Re: Turkey Point Units 3 and 4
Docket Nos. 50-250 and 50-251
Response to NRC Request for Additional Information Regarding
Fuel Storage Criticality Analysis License Amendment Request No. 207

RESPONSE TO NRC RAI REGARDING EPU LAR NO. 207
FUEL STORAGE CRITICALITY ANALYSIS

Response to Request for Additional Information

Figure 1.1 – Illustration of Fuel Assembly Removal

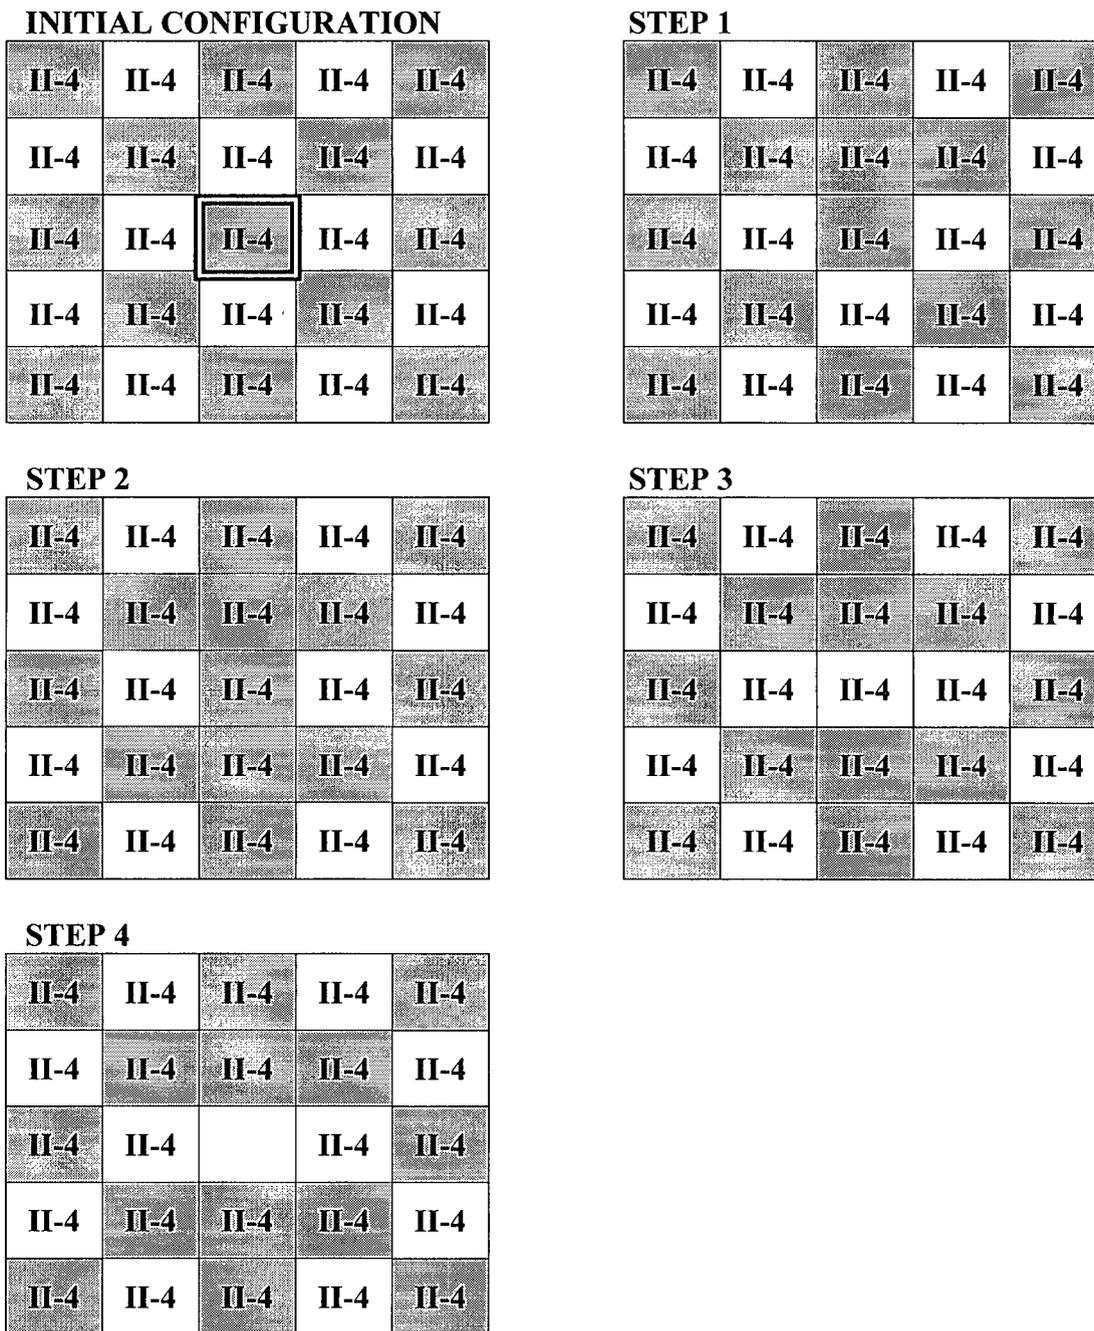
- 1. On page 4 of the license amendment request, the licensee stated that “Metamic inserts are installed into selected spent fuel pit rack cells and establish allowed spent fuel storage configurations based on assembly initial enrichment, burnup and post irradiation cooling times.” Explain how it is determined which spent fuel pool rack cells receive Metamic inserts?**

Metamic panels are inserted into the spent fuel pool rack cells to fulfill the requirement that every 2x2 array in the spent fuel pool is in one of the allowable configurations of the criticality analysis. The allowable configurations are noted on pages 5-2 and 5-3 of WCAP-17094-P Revision 3, as well as in the proposed Technical Specification pages included with the License Amendment Request.

The initial implementation process is to re-arrange the fuel assemblies and Metamic panels in the spent fuel pool to make it compliant with the allowable configurations of the new criticality analysis, while meeting the requirements of the current Technical Specifications at all times. Subsequent to the initial implementation, all spent fuel pool move plans will be prepared and approved in accordance with procedures that require that the spent fuel pool remain in compliance with the criticality requirements after every move of a fuel assembly or Metamic panel (or any other item).

To further illustrate, Figure 1-1 outlines the process to remove a fuel assembly that is in a location with a Metamic panel. The initial configuration highlights that fuel assembly, which is in the center of a 5X5 array of assemblies of Category II-4 fuel. That fuel category requires that every 2x2 has two Metamic panels (shaded cells have Metamic panels inserted). Step 1 in the sequence notes that a Metamic panel has been inserted into the location in the second row, third column, and Step 2 notes that a Metamic panel has been inserted into the location in the fourth row, third column. Those two insertions are necessary to ensure that all 2x2 arrays remain in an allowable configuration after the panel is removed from the center location, and that is noted in Step 3. Finally, Step 4 notes that the central fuel assembly has been removed. As noted in this example, the Metamic panels are inserted into spent fuel pool rack cells as needed to remain compliant with the allowable configurations of the criticality analysis.
